Planning Commission Regular Meeting | 5:30 PM

Wednesday, October 29, 2025

Final Plan Review for New Home

Hearing Date:	October 29, 2025
File Name and Process:	Single-Family Residence Final Plan Review
Owner/Applicant:	Clay & Becky Stevens
Representative:	Taylor Hermes & Rick Hermes, Minturn North Construction Company
Legal Description:	Subdivision: MINTURN NORTH PUD Lot: 1
Address:	0246 Miles End Lane
Zoning:	Game Creek Character Area – Minturn North PUD Zone District
Staff Member:	Madison Harris, Planner I
Recommendation:	Approval

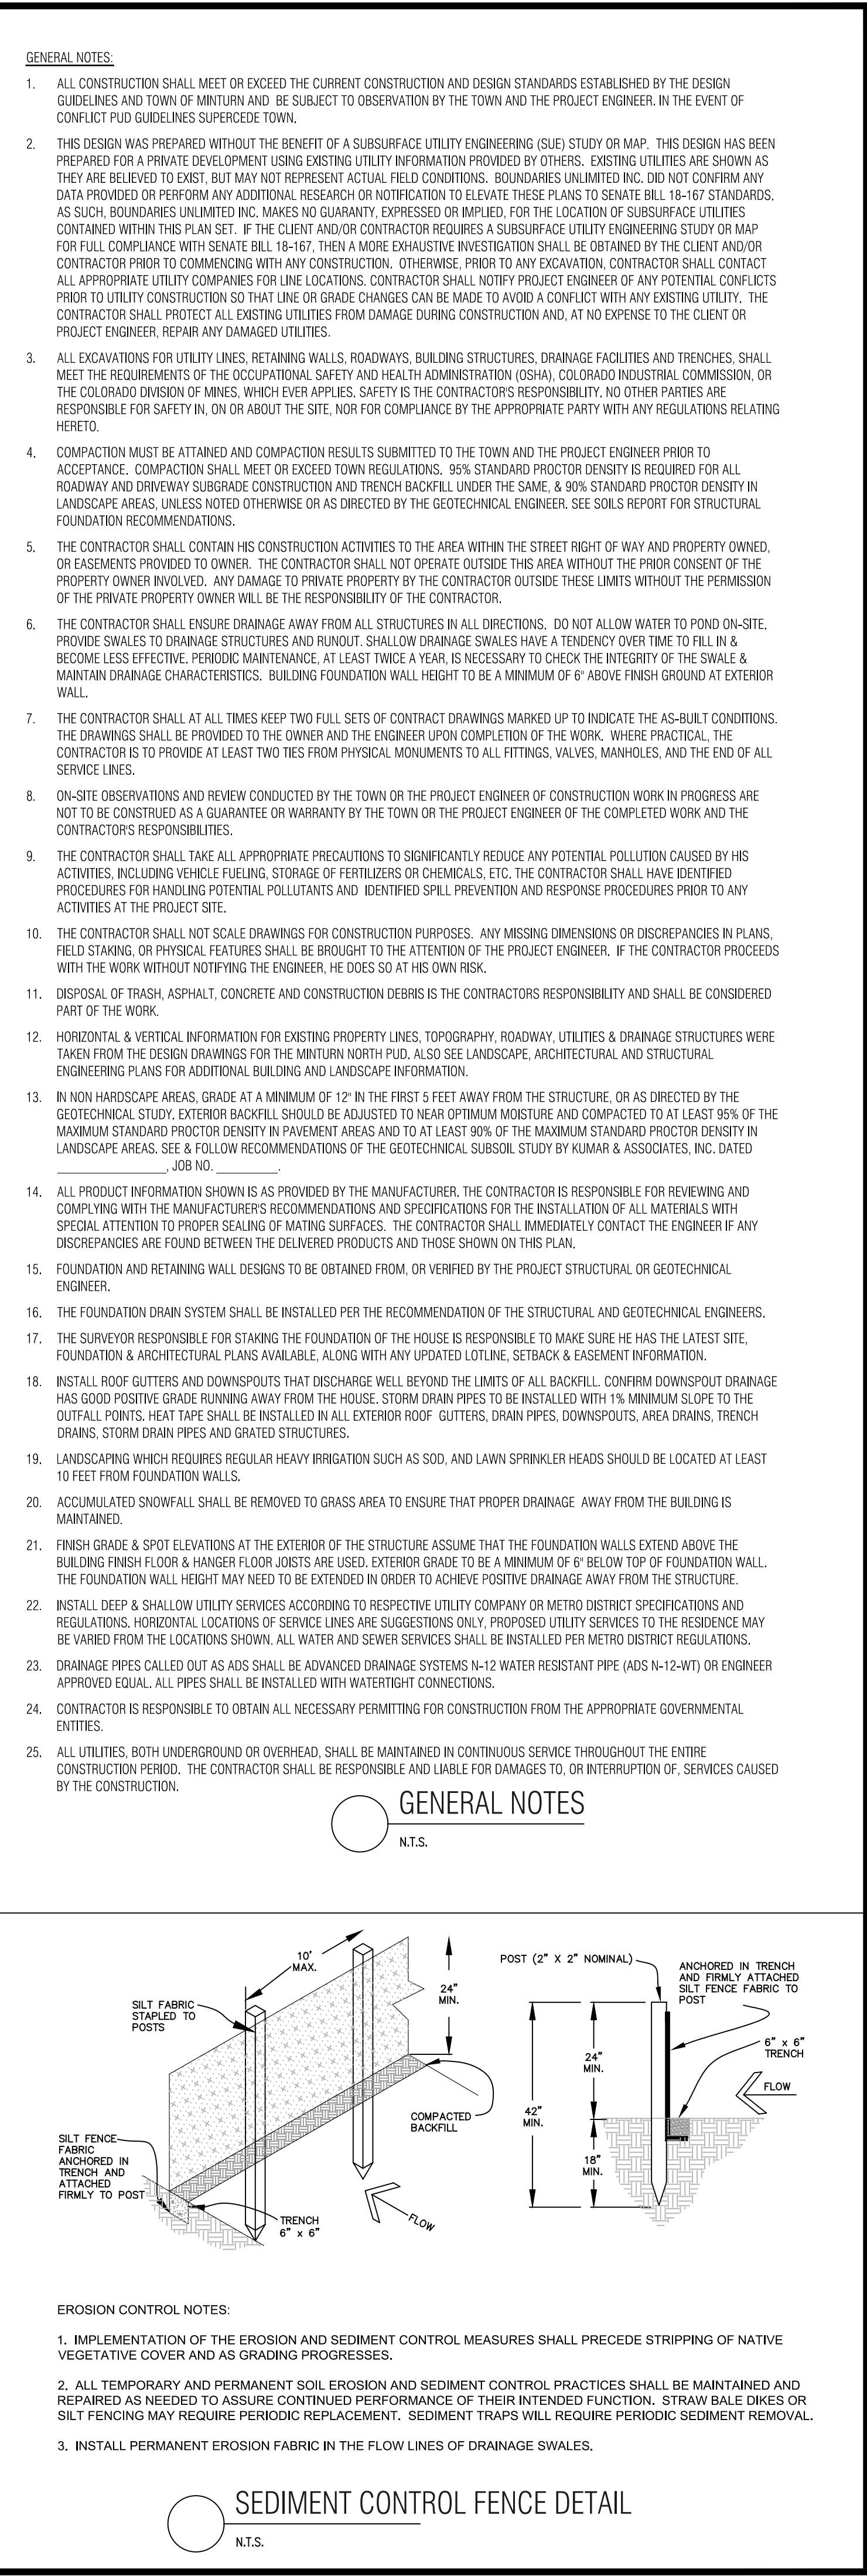
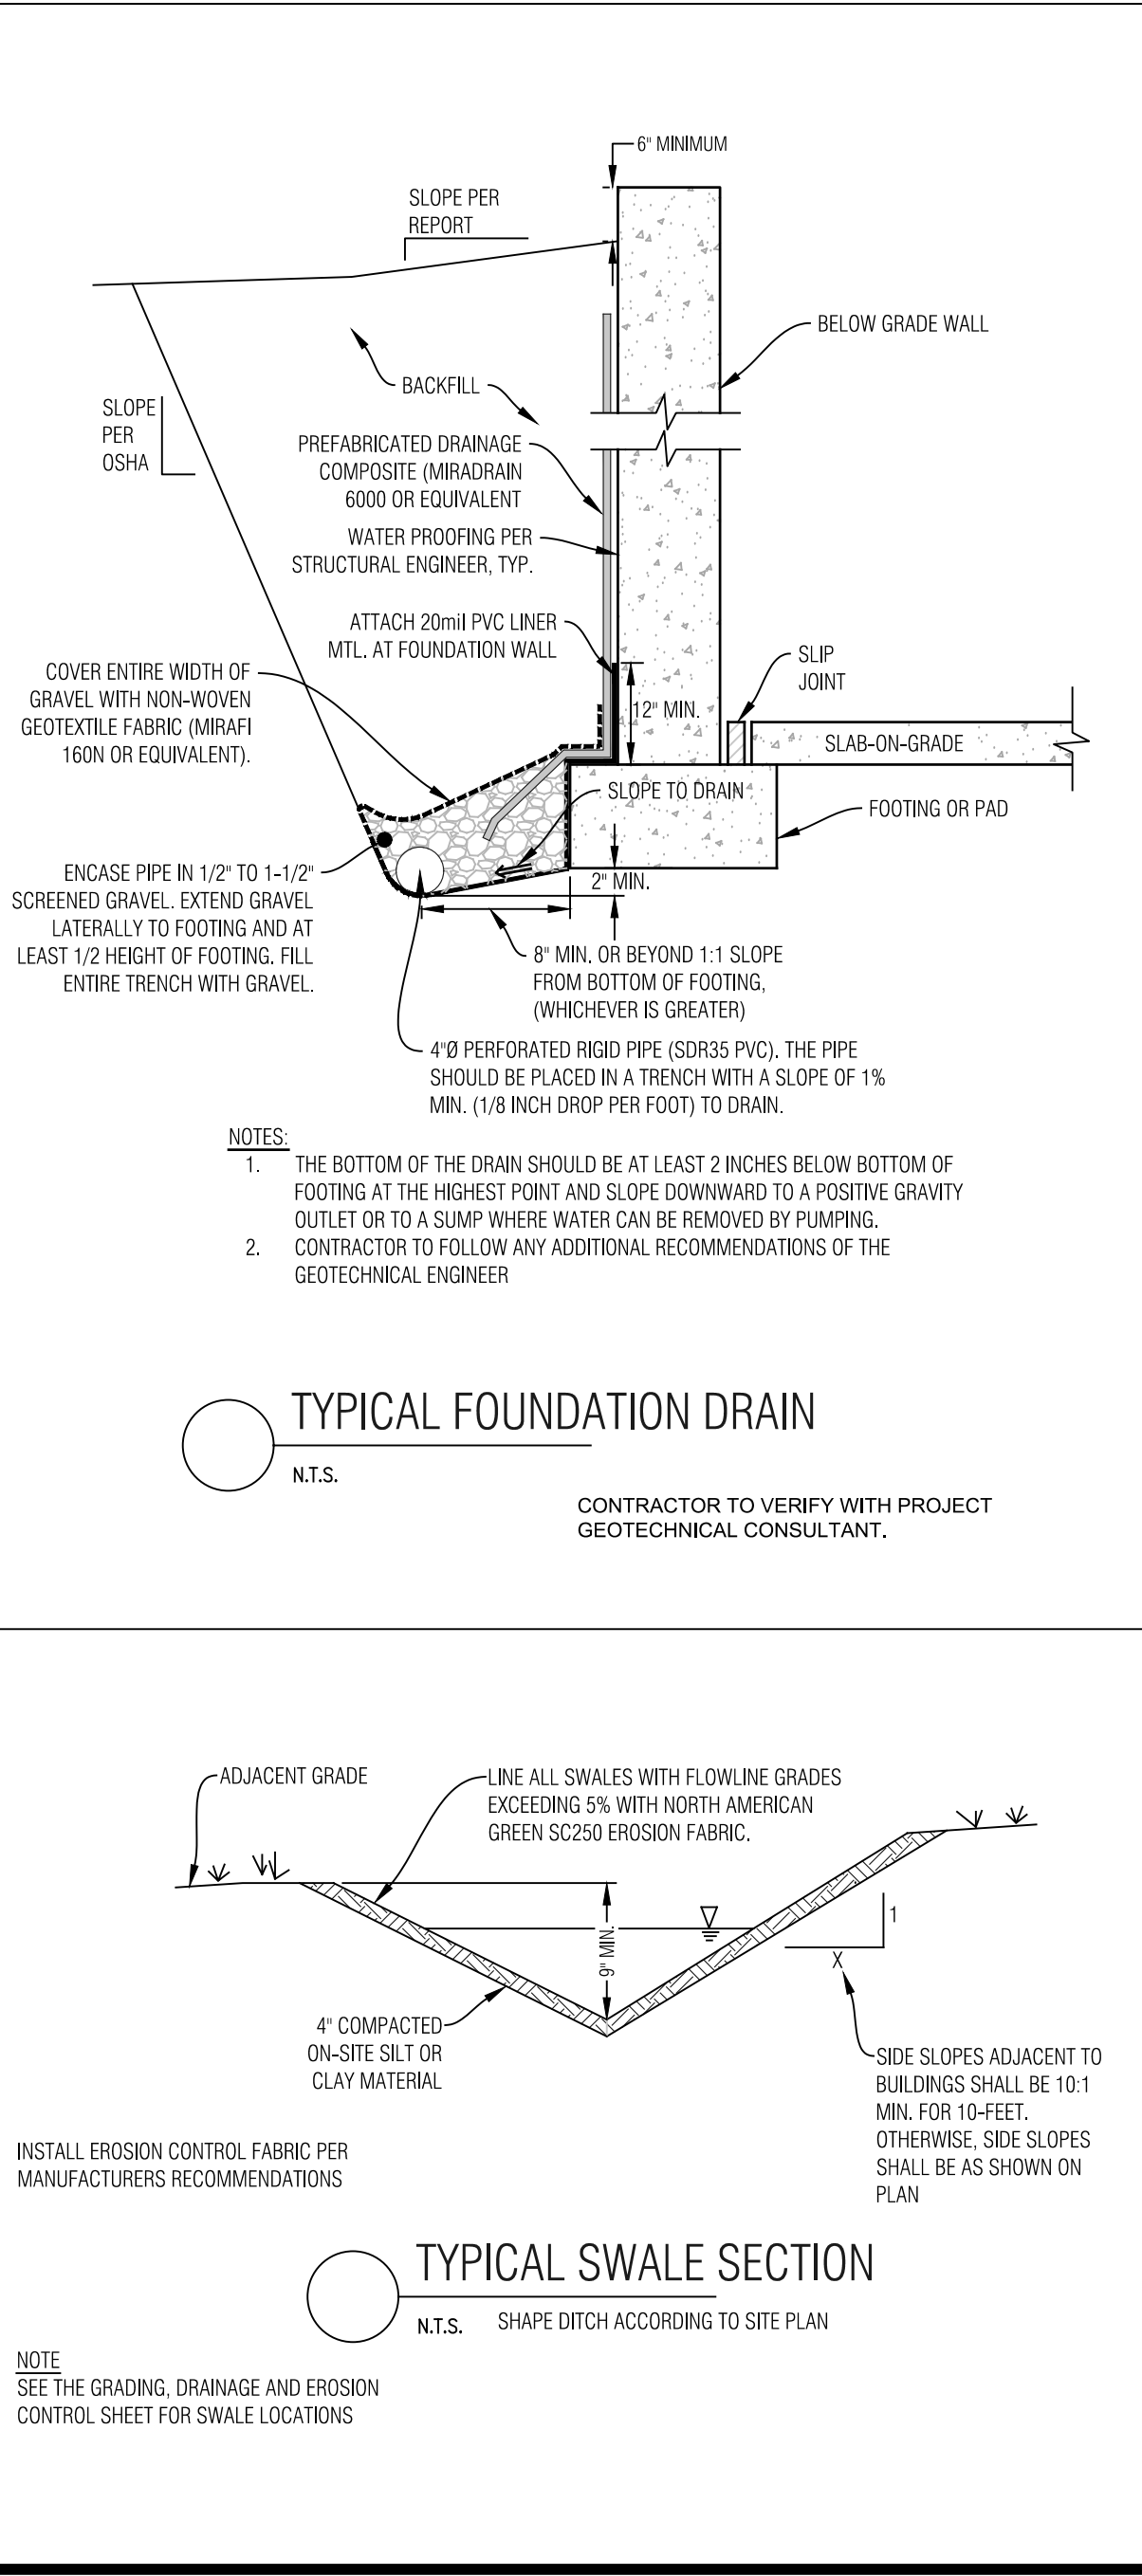
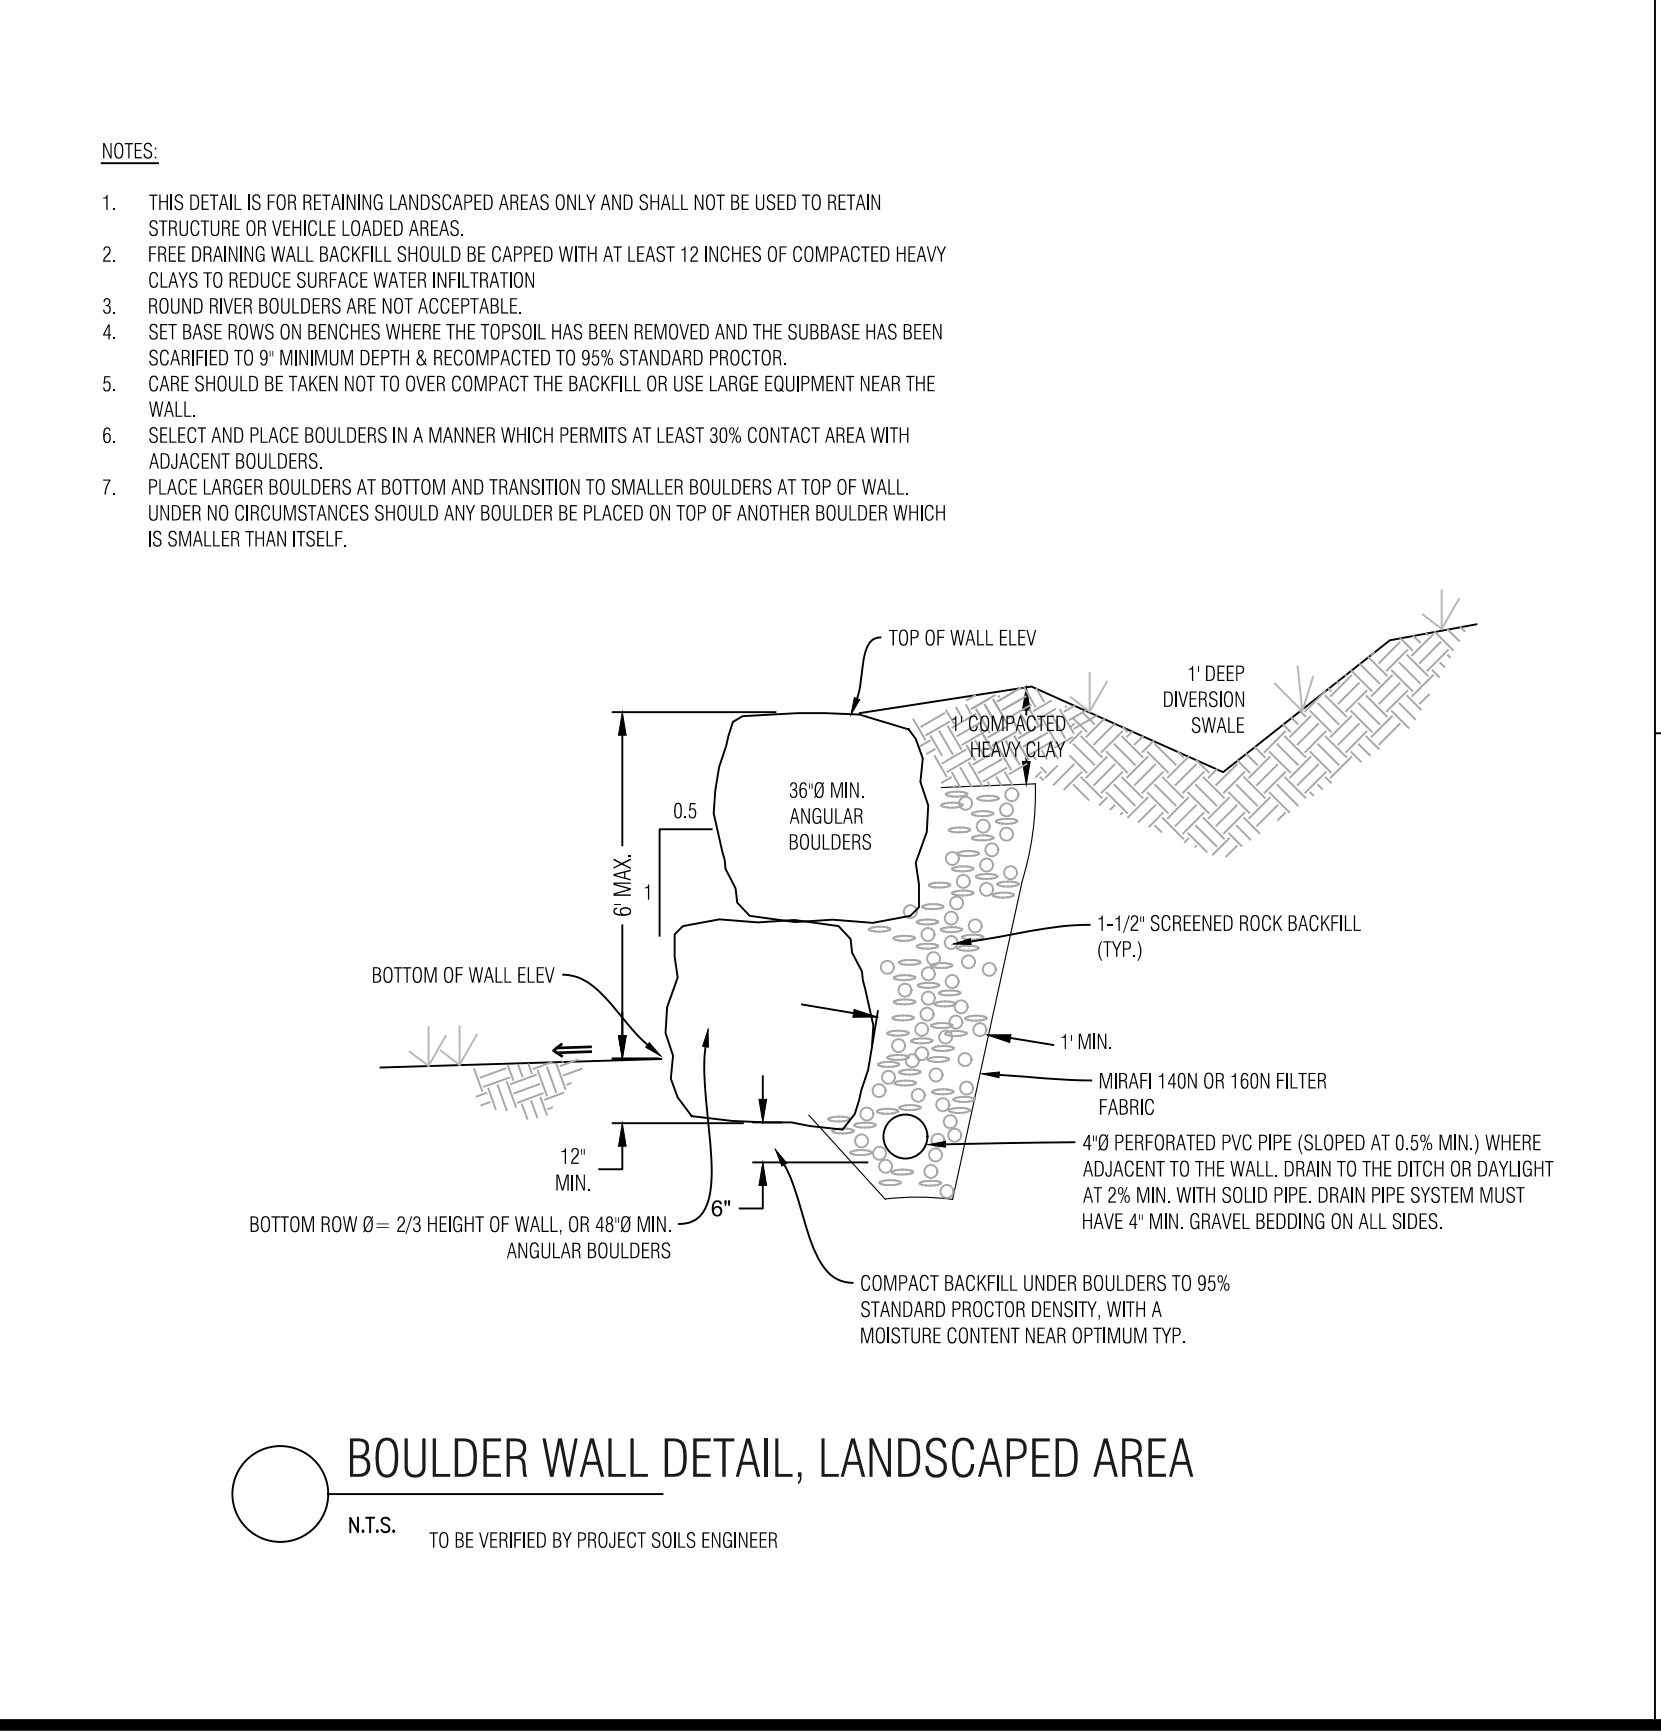
2. Sheet C1 of the Plans *“Lot 1 Minturn North PUD; Site Grading and Drainage Plan”* dated September 18, 2025, by Boundaries Unlimited presents the proposed Site Plan.
 - i. The site plan shows the 30’ Setback to the “Ordinary High Water Mark” (OHWM) of Game Creek. Improvements are located outside of the OHWM setback as shown.
 - ii. The site plan identifies the location of the 100 Year Flood Plain and the “Proposed 100 Year Mudflow extents.” Improvements are located outside of the identified limits of the hazard zones.
 - iii. The water curb stop is located in the driveway and should be protected from snowplowing damage by enclosing it in a water valve box.

Sheet C1 of the Plans *“Lot 1 Minturn North PUD; Site Grading and Drainage Plan”* dated September 18, 2025, by Boundaries Unlimited presents the proposed site grading, drainage, and erosion control.
